UNITED STATES PATENT AND TRADEMARK OFFICE

APPLICATION NO.	FILING DATE	FIRST NAMED INVENTOR	ATTORNEY DOCKET NO.	CONFIRMATION NO.
10/791,610	03/03/2004	Chin-Ching Hsien	J5P4012-GFP-922331	2706

Office Action Summary	Application No. 10/791,610	Applicant(s) HSIEN, CHIN-CHING	
	Examiner Hadi Shakeri	Art Unit 3723

DETAILED ACTION

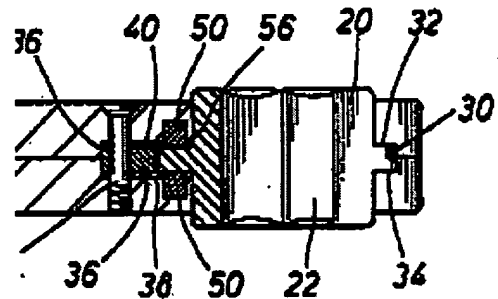
5. Claims 1, 2, 3, 5 and 6 are rejected under 35 U.S.C. 102(b) as being anticipated by Baron (5,417,129).

Baron discloses all of the limitations of claim 1, i.e., a spanner body having a receiving chamber, with two control groove (defined in the cavity accommodating the two members 50), a toothless ratchet (20), two control device formed by a control unit (50) and an elastomer (52).

Wherein the control unit is a rectangular or a polygonal cylinder (Fig. 2) having a chamfered surface (Fig. 5).

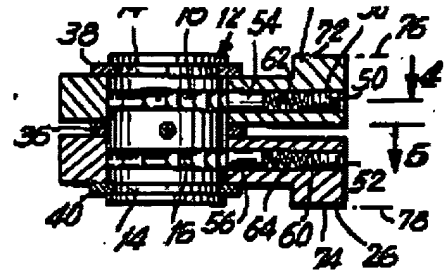
7. Claim 5 is rejected under 35 U.S.C. 103(a) as being unpatentable over Baron.

Baron meets all the limitations of claim 5, except for the control unit to have a hexagonal shape. It would have been obvious to one having ordinary skill in the art at the time the invention was made to make the wedge hexagonal, since applicant has not disclosed that hexagonal shape solves any stated problem or is for any particular purpose and it appears that the invention would perform equally well with a rectangular cylinder as disclosed and, since changing shape, involves only routine skill in the art.
